***Remedial Design/Remedial Action Scope of
Work for the V-Tanks (TSF-09 and TSF-18)
at Test Area North, Waste Area Group 1,
Operable Unit 1-10***

DOE/ID-11119
Revision 0

Agency Comment Resolution Forms

Figure 3. Working schedule for OU 1-10 Group 2 V-Tanks RD/RA.

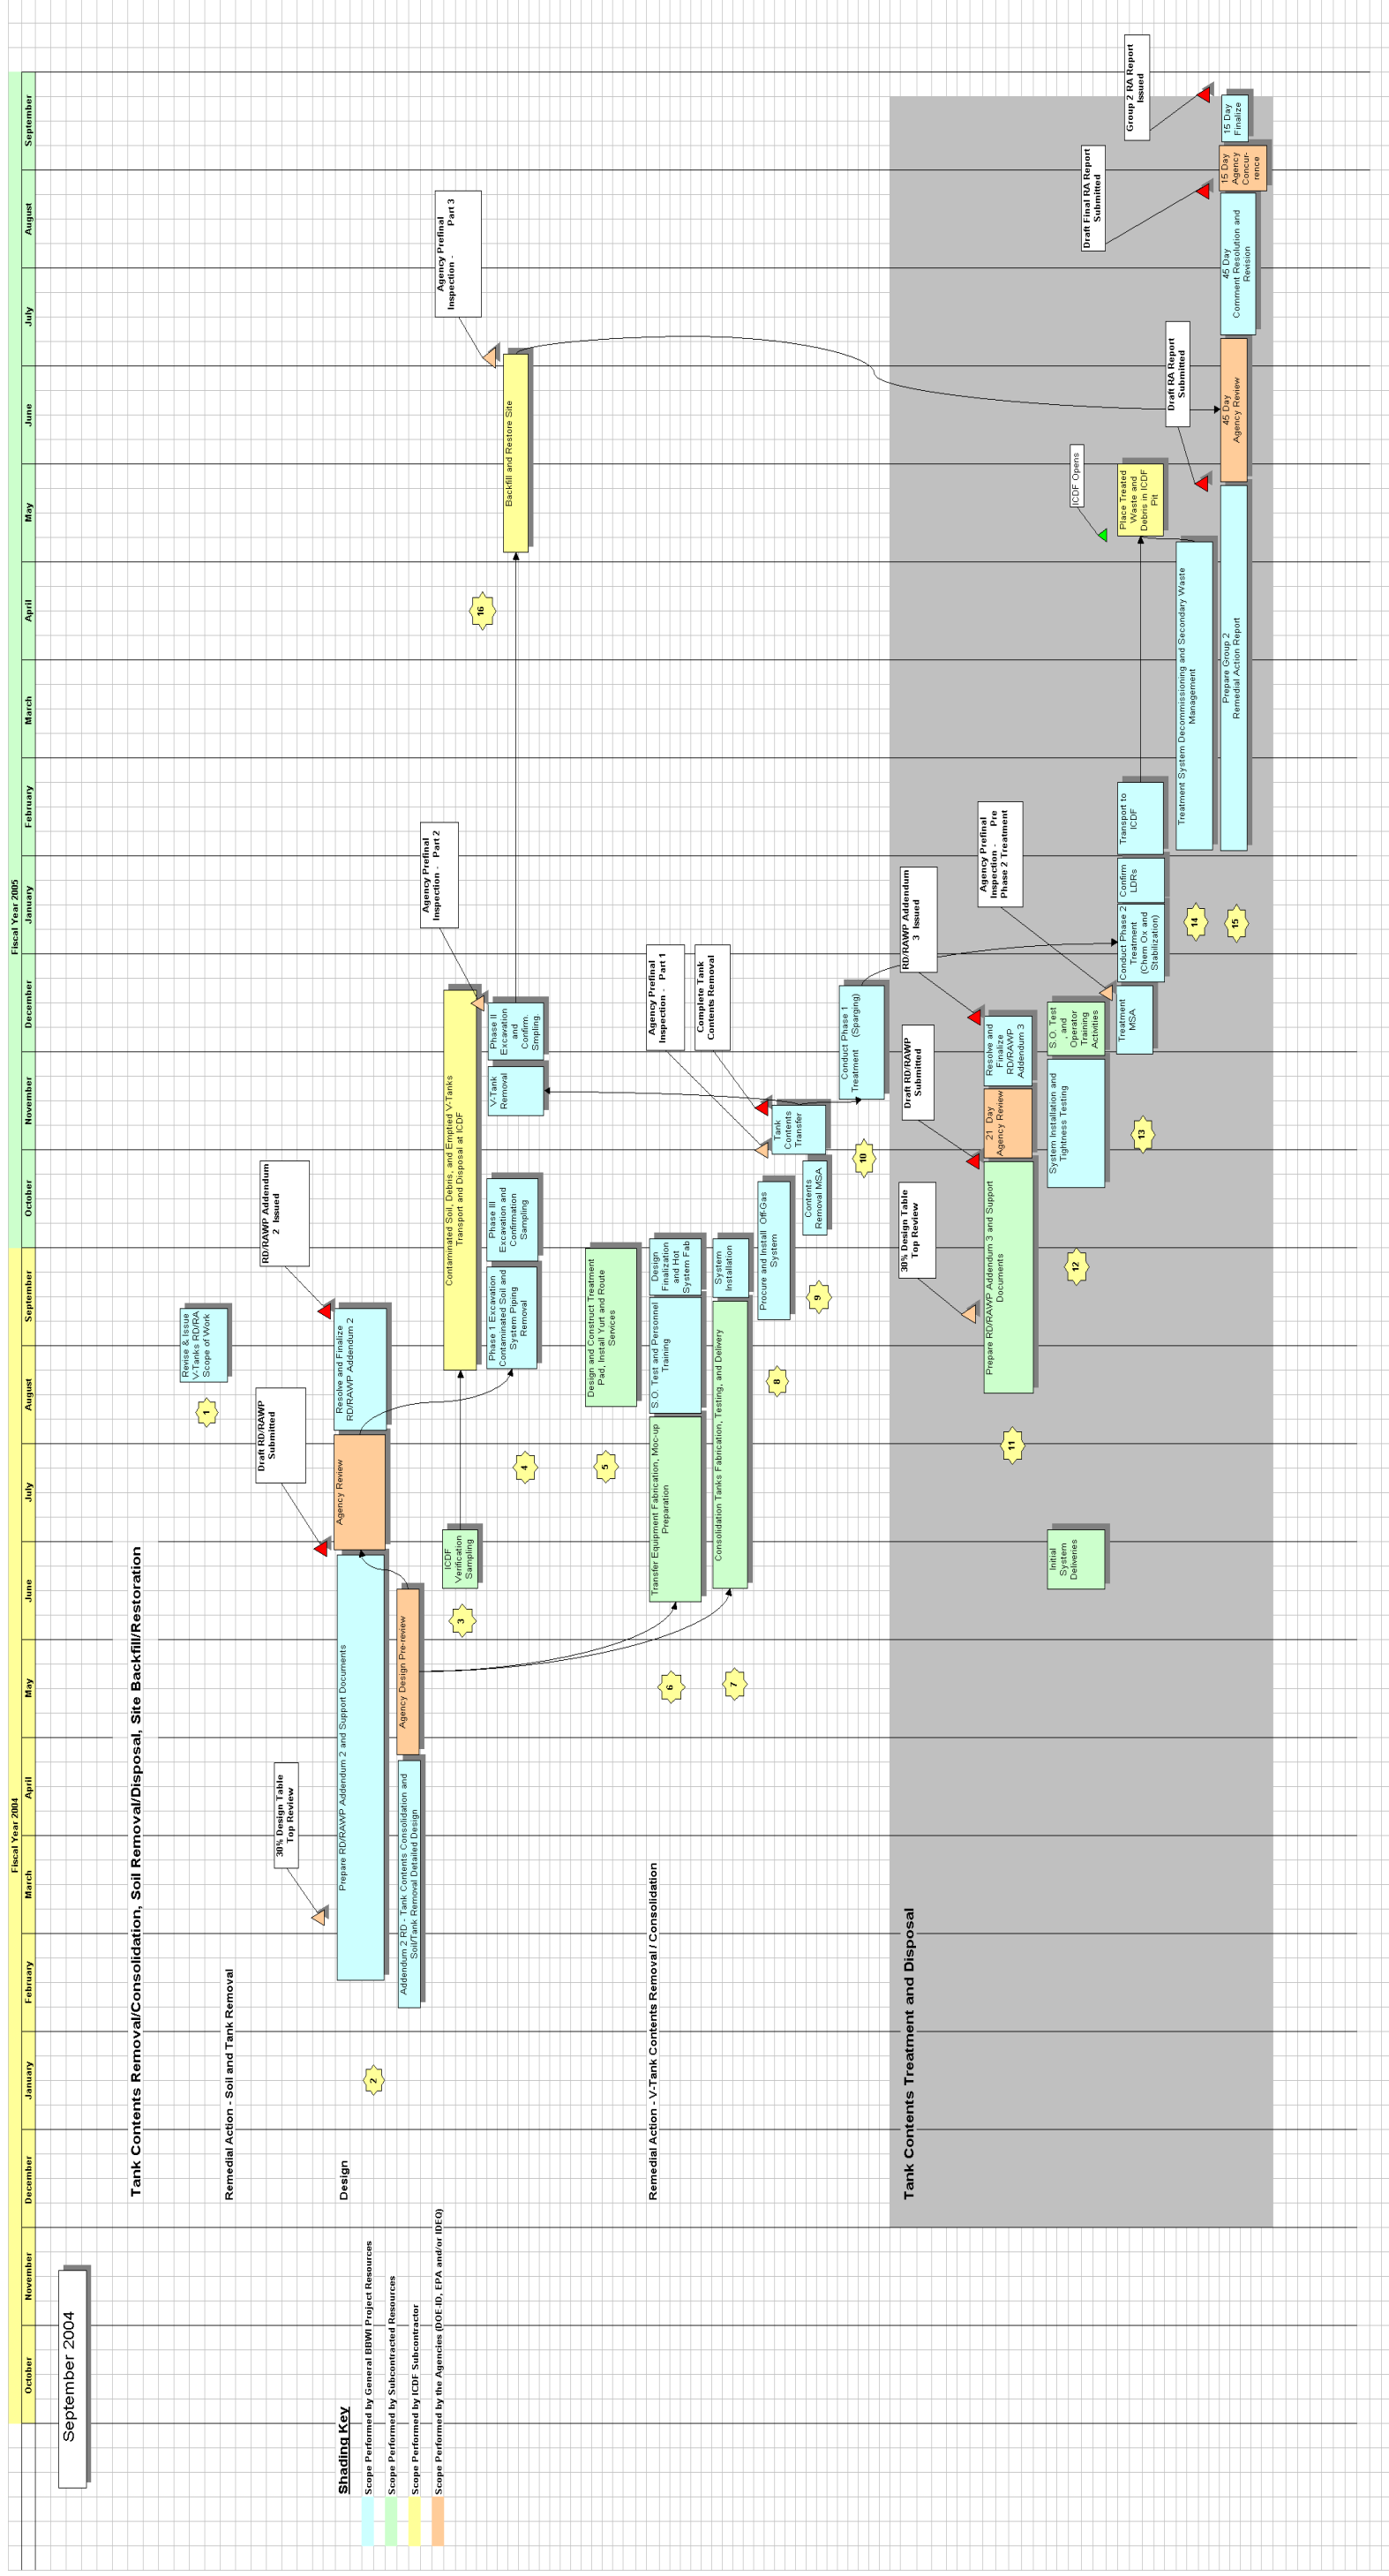
ITEM NUMBER	SECTION NUMBER	PAGE NUMBER	COMMENT	RESOLUTION
5	6 Figure 3	19	EPA assumes this schedule is a working schedule. If there is an enforceable schedule elsewhere that location should be referenced in Section 6. (There is a reference to the Addendum 2 Work Plan but this reviewer was unable to locate such a schedule.) Otherwise the enforceable schedule should be included in the SOW.	Comment noted. Figure 3 is a working schedule. The enforceable milestone dates for submittal of the draft OU 1-10 V-Tanks Addendums are provided in Section 6, Table 2. The introductory paragraph of Section 6 has been changed to the following: "This section provides a working schedule (Figure 3) for the V-Tanks remedial design and remedial action. This working schedule has been developed to support the accelerated schedule for V-Tanks remediation. Table 2 provides a deliverable schedule for documents that require Agency review/approval and have enforceable deadlines. As defined in Section XII of the FFA/CO and agreed to by the Agencies, the enforceable milestones include the submittal of the draft V-Tanks RD/RAWP Addendum 2 and Addendum 3. Additional enforceable milestones will be addressed in the V-Tanks RD/RAWP Addendum 3."
